AMENDMENTS TO THE DRAWINGS

REMARKS

By this Amendment, claims 7-8 and 10-12 are cancelled, claims 1-6, 9 and 13-17 are amended, and claims 18-21 is added. Thus, claims 1-6, 9 and 13-21 are active in the application. Reexamination and reconsideration of the application are respectfully requested.

FIG. 9A

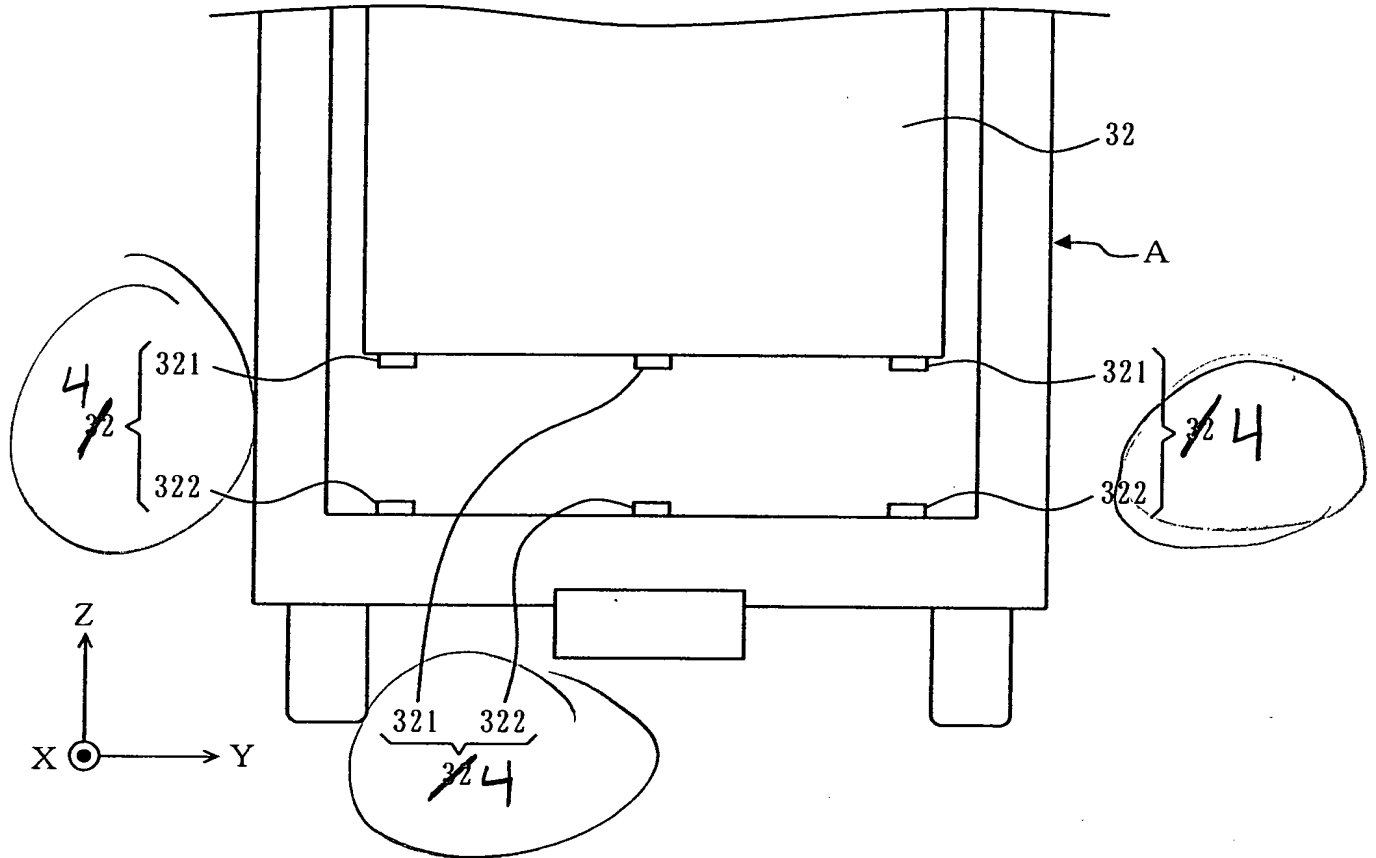
Replacement formal drawings of Figures 1-53 are submitted concurrently herewith under a separate cover letter in order to correct mislabeled reference numerals illustrated in Figures 9A, 9B, 16A, 16B, 17, 18, 19A, 19B, 38, 40-44, 45A, 45B and 48.

In particular, paragraphs [0060] and [0063] of the specification, for example, describe a fixing member 4 which includes pairs of magnets 321 and 322. However, Figures 9A and 9B illustrate the magnets 321 and 322 as being members of reference numeral 32, which is used in the specification and the drawings to denote the exterior screen of the exterior screen device 3 of the present invention. Accordingly, Figures 9A and 9B have each been revised to denote each pair of magnets 321 and 322 as being members of reference numeral 4 (the fixing member), instead of reference numeral 32.

FIG. 16A

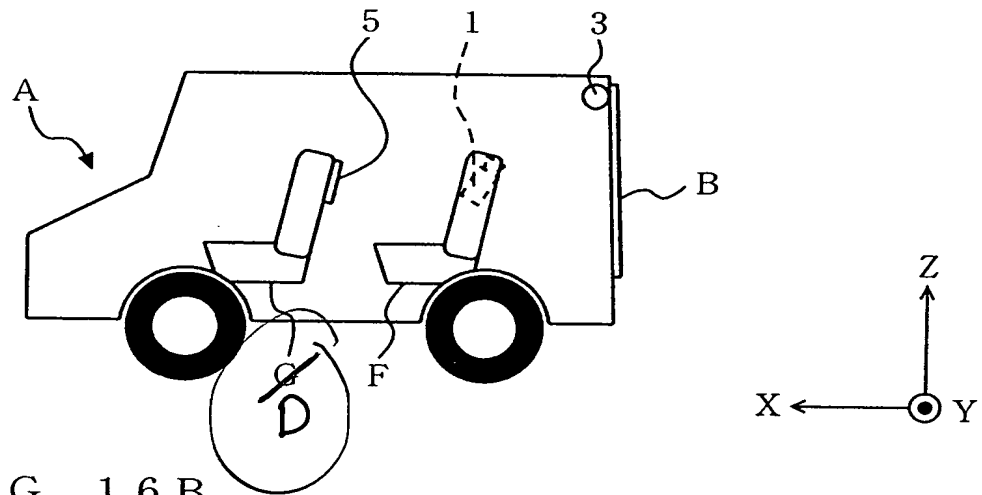
In addition, Figures 16A, 16B, 17, 18, 19A and 19B each illustrated the front seat of the vehicle A with reference numeral "G." However, reference numeral G is used in the specification and the drawings to denote the opening at the back door B or rear hatch B of the vehicle A. Furthermore, the specification describes the front seat of these drawings with reference numeral D, not reference numeral G. Accordingly, Figures 16A, 16B, 17, 18, 19A and 19B have each been revised to denote the front seat with reference numeral D, instead of reference numeral G.

FIG. 38

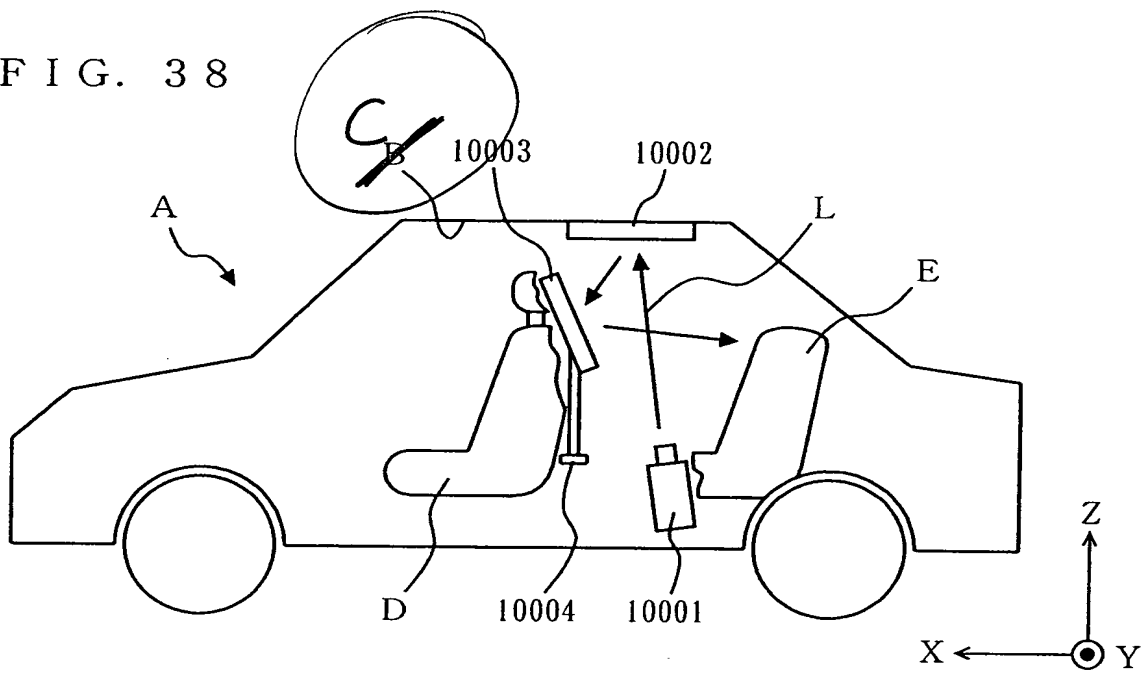
Furthermore, Figures 38, 40-44 and 48 each illustrated the ceiling of the vehicle A as corresponding to reference numeral "B." However, the ceiling of the vehicle A is

denoted with reference numeral "C" throughout the specification and in the drawings preceding Figures 38, 40-44 and 48. Accordingly, Figures 38, 40-44 and 48 have each been revised to denote the ceiling of the vehicle A with reference numeral C, instead of reference numeral B.

FIG. 45A

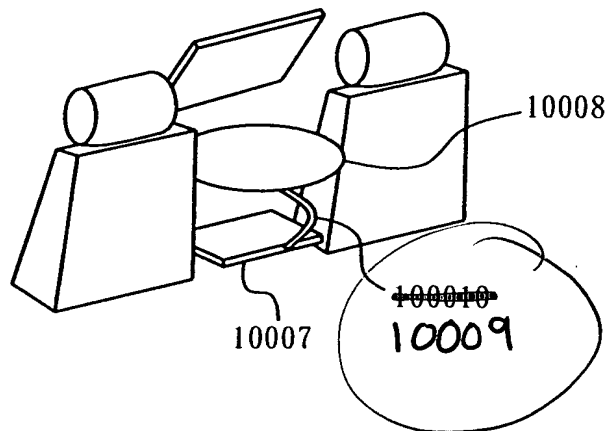
Moreover, the specification describes that display system illustrated in Figures 43, 44, 45A and 45B includes a first supporting member 10009 for supporting the lens 10008 and for covering the optical path for the light beam L emitted from the display device 10007 between the display device 10007 and the lens 10008. However, in Figures 43, 44, 45A and 45B, the first supporting member 10009 was incorrectly denoted with reference numeral 100010, which is also used to denote the reflecting member 100010 mounted near the ceiling C of the vehicle by means of the second supporting member 100011. Accordingly, Figures 43, 44, 45A and 45B have each been revised to denote the first supporting member with reference numeral 10009, instead of reference numeral 100010.
